RE: The Towers, LLC (“Vertical Bridge”) Response to ROWE’s 09/25/2025 Site Plan Review of Proposed Telecommunications Tower at 2304 West Wilson Road

Schedule A Revised Site Plan

OVERALL PARCEL SKETCH

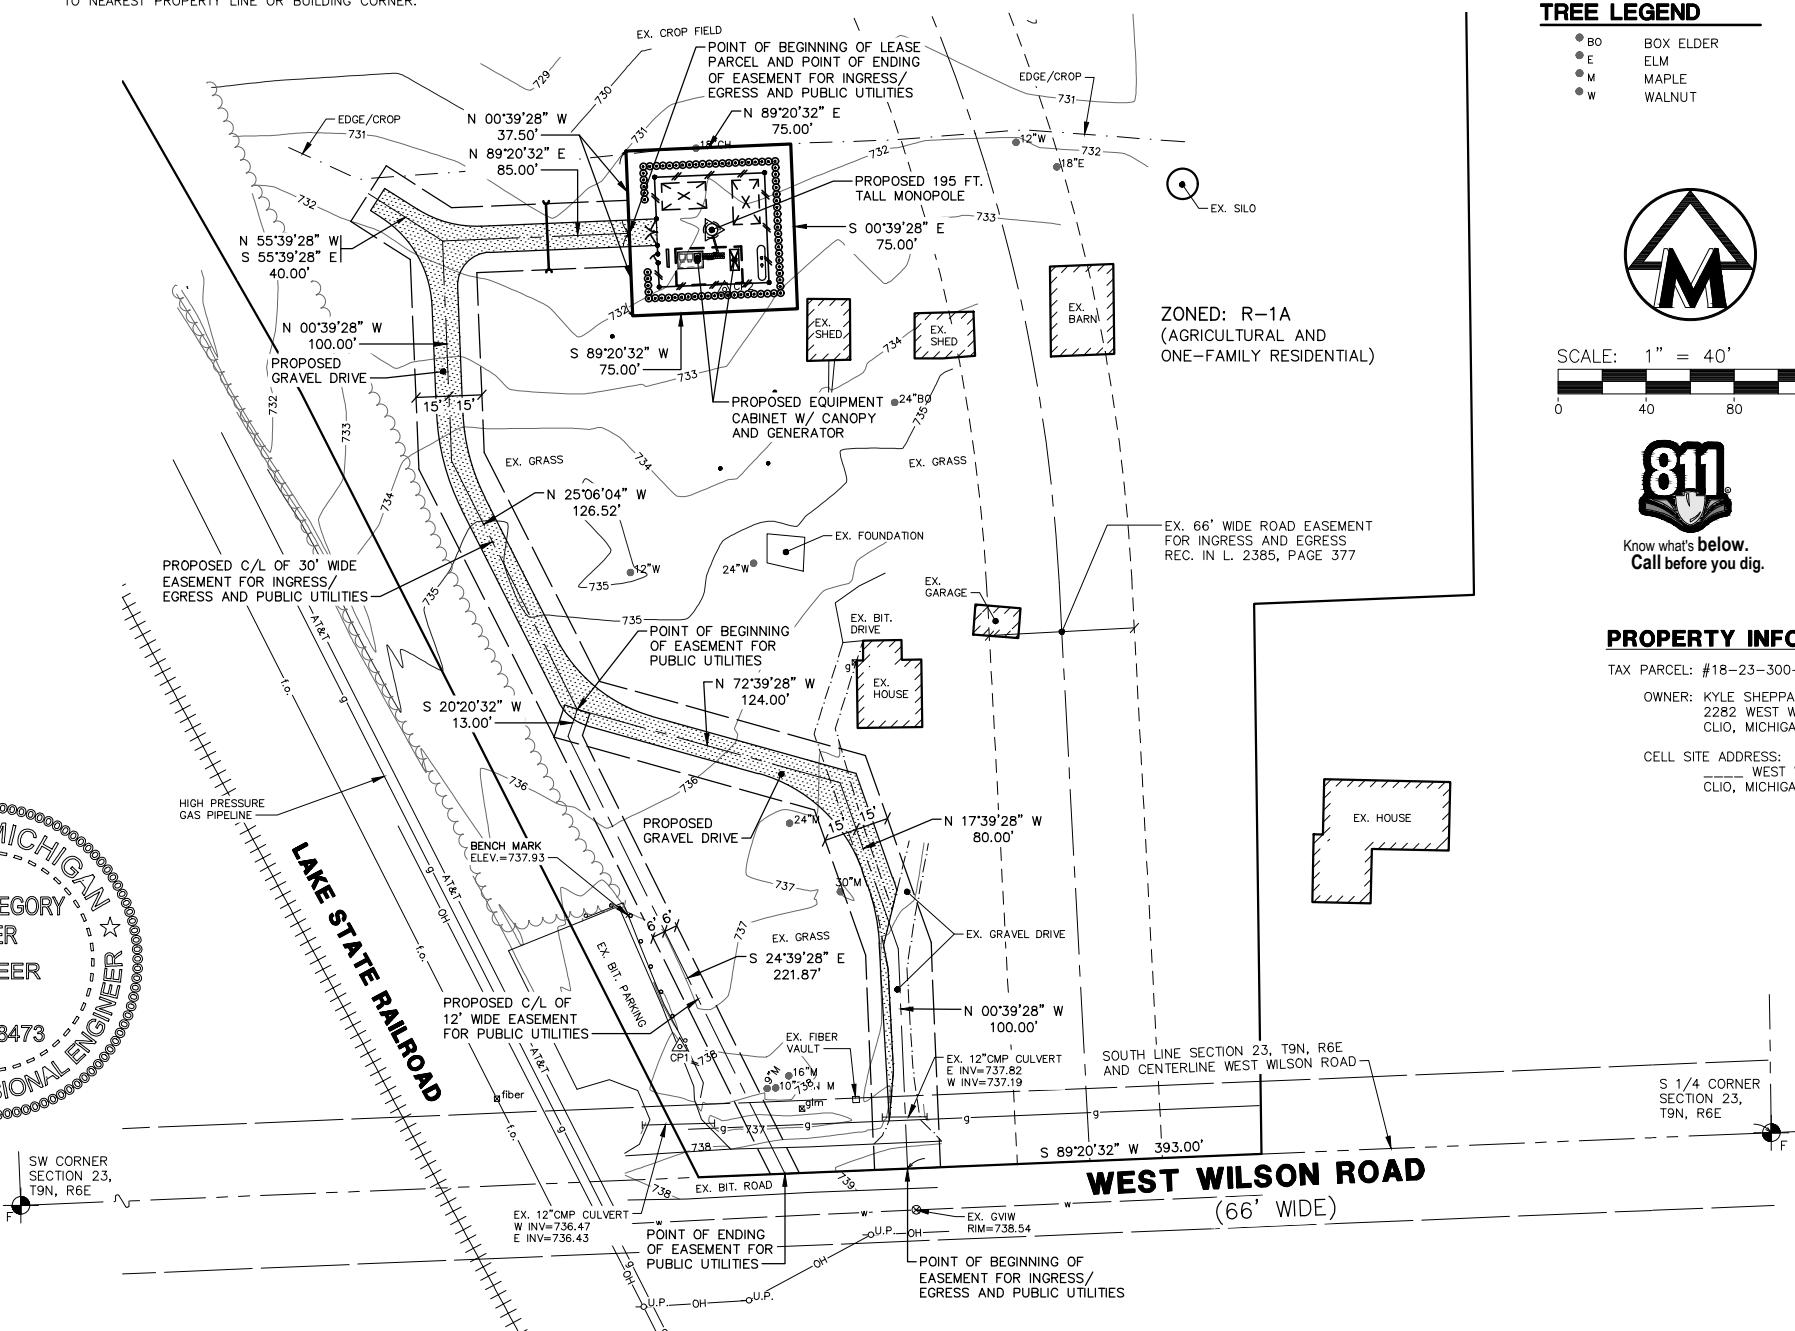
Sec 602.1.I – The location of all existing and proposed structures on the subject property, including the actual setback of all structures to be retained or constructed. The measurements are to the fence of the equipment compound, please verify. The site plan indicates that there is a house on the property, but only part of it is shown as opposed to the other accessory structures. Does the applicant intend to demolish the house?

A. Tower shall be located centrally on a continuous parcel having a dimension of at least equal to the height of the tower measured from the center of the base of the tower to all points of each property line. Please clarify where the measurements are being calculated from, the fence or from the center of the base of the tower to all points.

- All distances shown are from tower center to nearest property line or building corner. A note confirming this was added on Sheet 1. No, the applicant doesn't intend to demolish the house, and the revised site plan showing the entire outline of the house is attached hereto.

- **All distances shown are from the tower center to the nearest property line or building corner. A note has also been added to Sheet 1.**

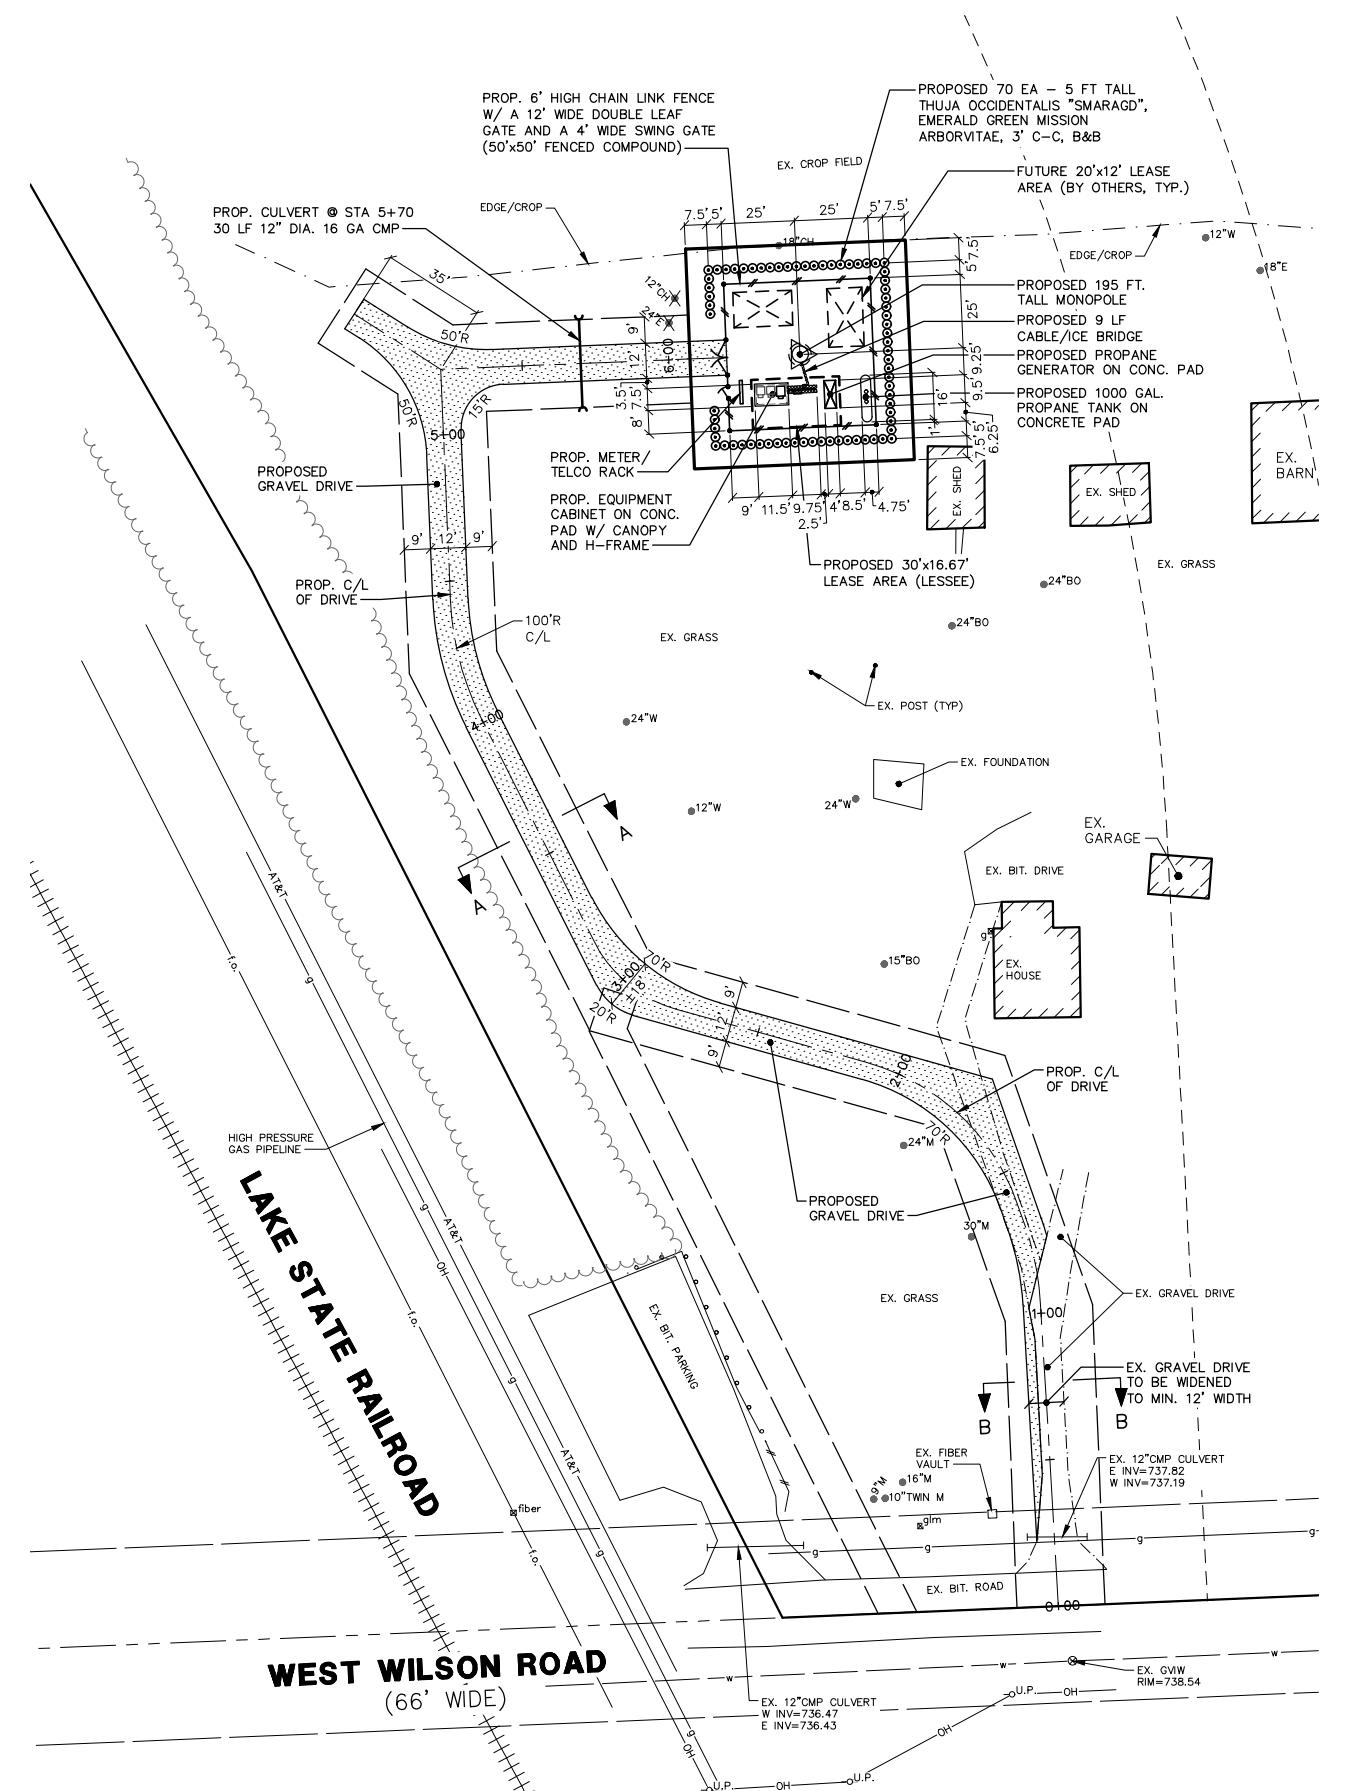
Sec 602.1.Z – The location, intensity, height, and orientation of all lighting. Note 4 – Sheet 3 of 5 states; “Tower light(s) may be required by the current regulations of the Federal Aviation Administration.” Please verify if a light is required, if not remove the comment. Elsewhere in the submittal it states no lighting on the tower is required.

Section 1301.1 – Plant Material Spacing – Do the proposed plant materials comply with the maximum spacing and staggering requirements of this Section? Narrow evergreens shall be planted not more than 3 feet on centers

- **Tower lights are not required. As requested, the comment in Note #4 Sheet 3 has been removed.**

- **The applicant added a note to Sheet 3 of 5 that the evergreens shall be planted not more than 3 feet on centers.**

GRADING PLAN

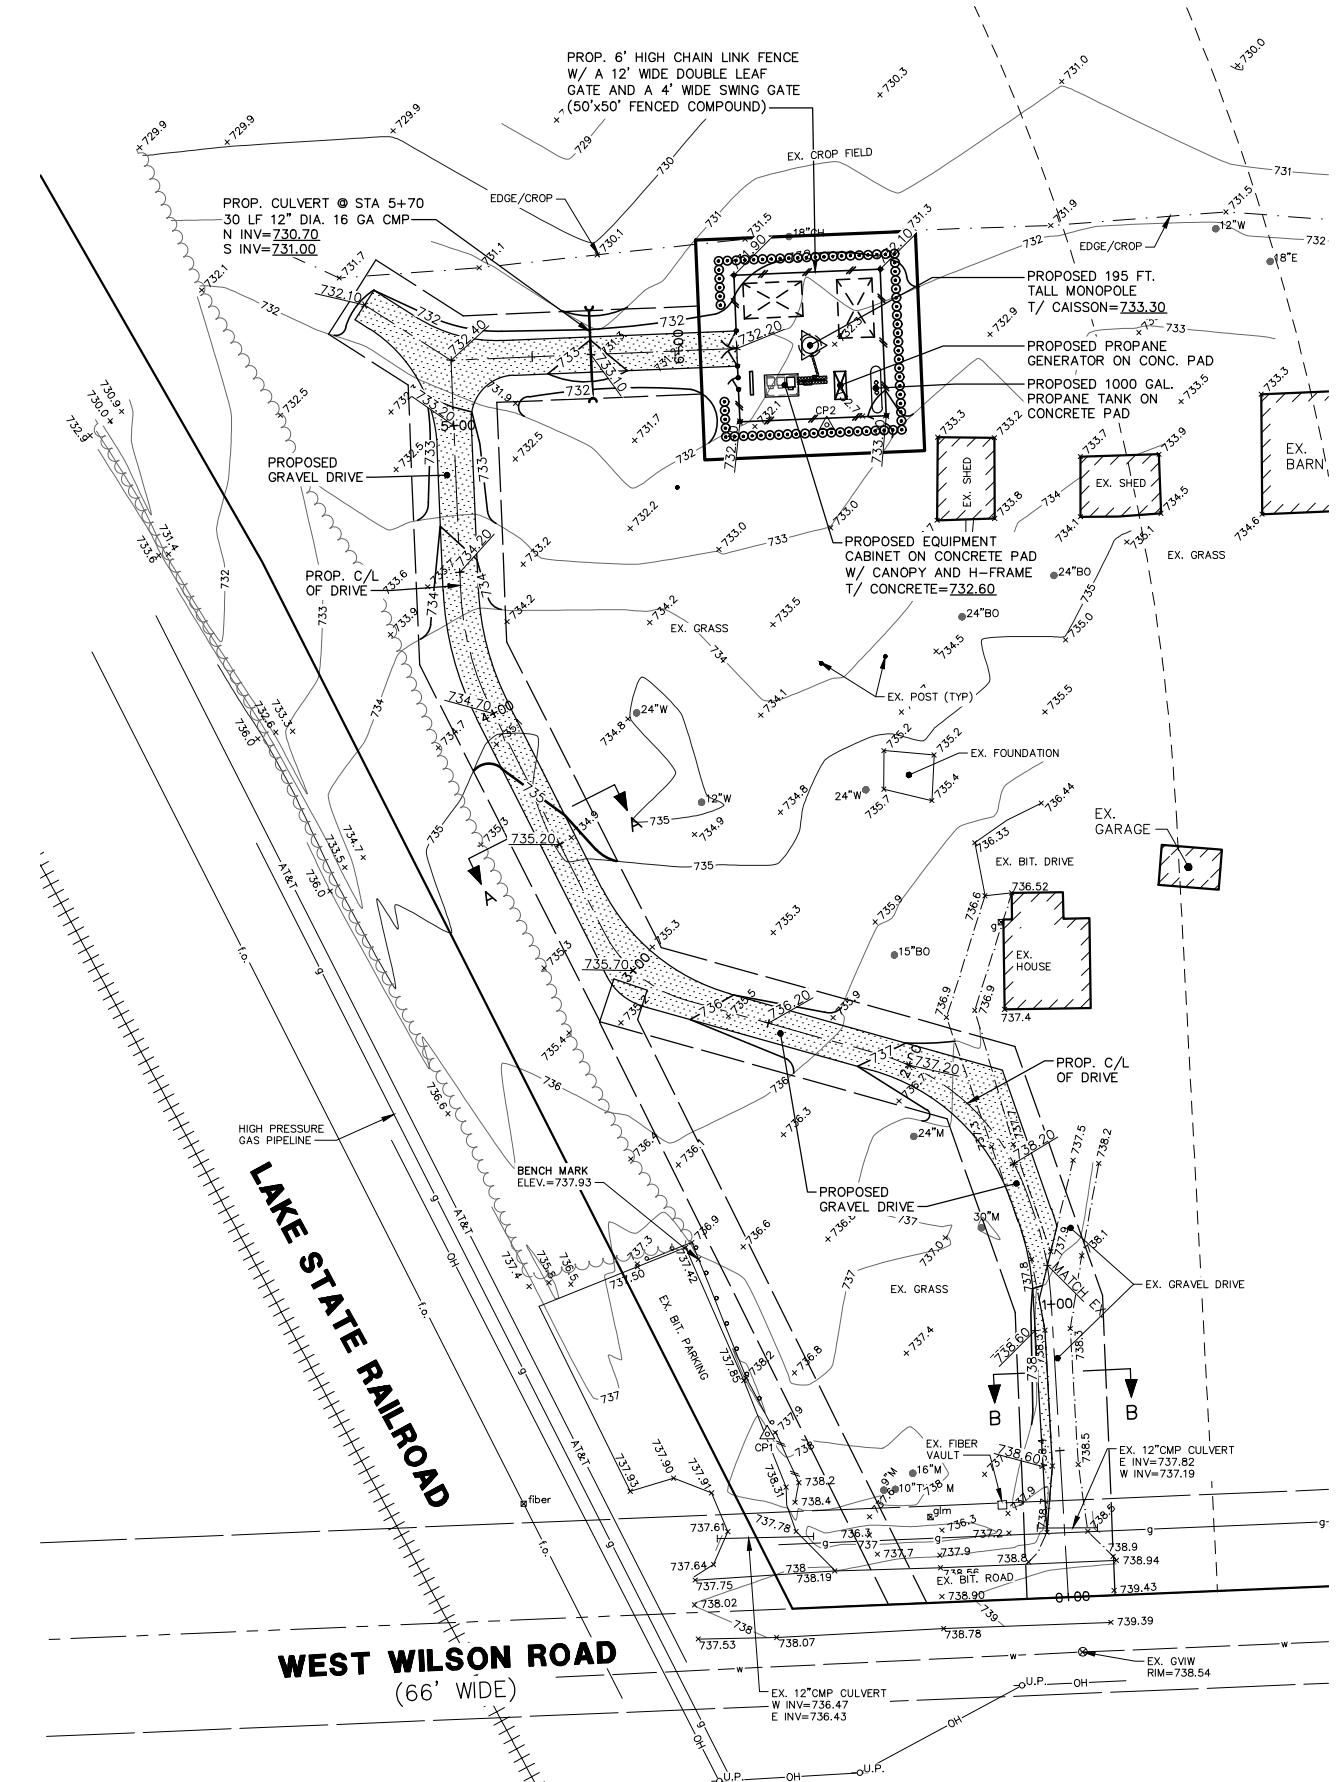
Sec 602.1.J – A preliminary grading plan in detail sufficient enough to determine whether or not extensive grading of the site is proposed and to enable the building height to be determined. Spot grades are sufficient but should include locations near the major corners of buildings. First floor elevations and rooftop elevations should be indicated, if the proposed building height is to be within 5 feet of the maximum height limit and the grade is not constant, the average grade along each major building face shall be provided. Please explain how drainage is going to occur with the proposed new driveway. Is the culvert county engineer approved? The improvements appear to be located in the right of way.

- The applicant is no longer proposing a new driveway but instead using the existing driveway for ingress & egress and widening the existing drive where needed to be a minimum width of 12'. Additionally, per the drainage narrative note on Sheet 4, the existing site drainage patterns will be maintained with all site runoff directed via overland flow in the direction that they flow currently. Culverts are shown as required to maintain these existing patterns.

CHAIN LINK FENCE DETAIL

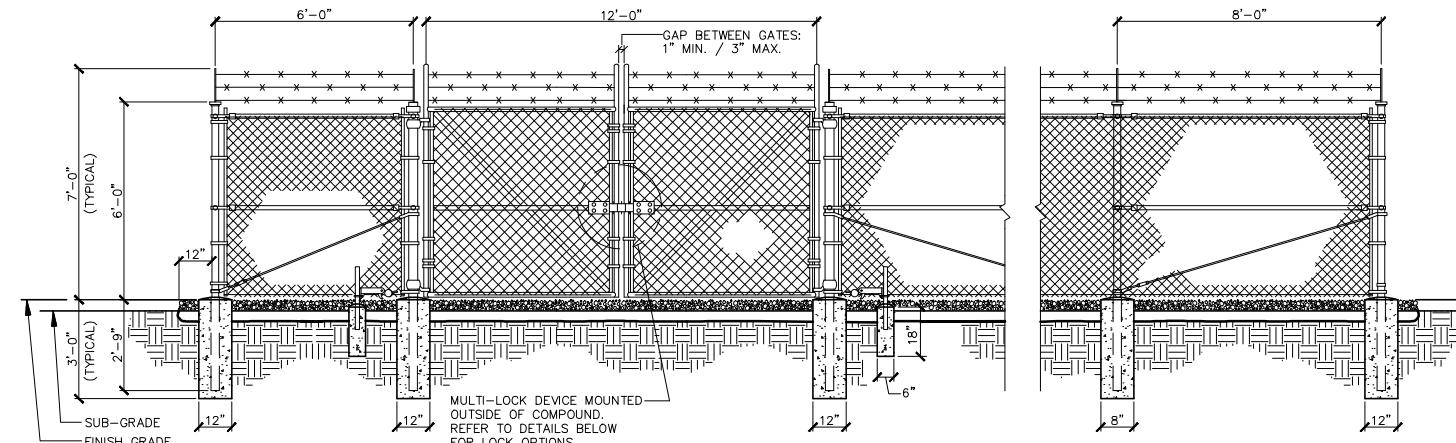
Section 1305.4 – Fences, Material Specifications – No person shall erect or cause to be erected a fence which is: (1) Made with or upon which is fixed barbed wire. (2) Has any protective spike, nail, or sharp pointed object. (3) Charged with electric current. The current proposal uses barbed wire around the top of the fence. It is also unclear if the barbed wire is angled inward or outward.

- **The applicant will apply for a fence permit with the appropriate issuing body prior to installation or erection of any fence within the corporate limits of Vienna Township.**

EQUIPMENT PAD LIGHTING DETAIL
NOT TO SCALE

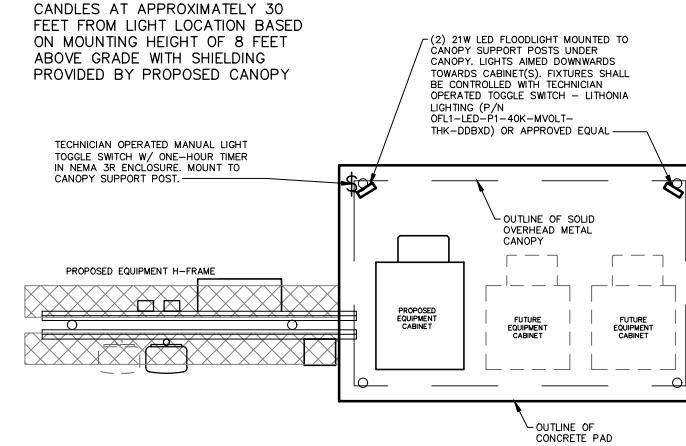
Section 507 – Exterior Lighting – Do the proposed lighting fixtures, including intensity, design, and placement on the photometric plan comply with these standards? – All lighting outdoor shall be downward facing and shielded so the surface of the source of the light shall not be visible from all adjacent properties and public right of way.

- **A note has been added that all outdoor lighting shall be downward facing. The two, low wattage (21W) under the equipment canopy will include the standard shielding from the manufacturer.**
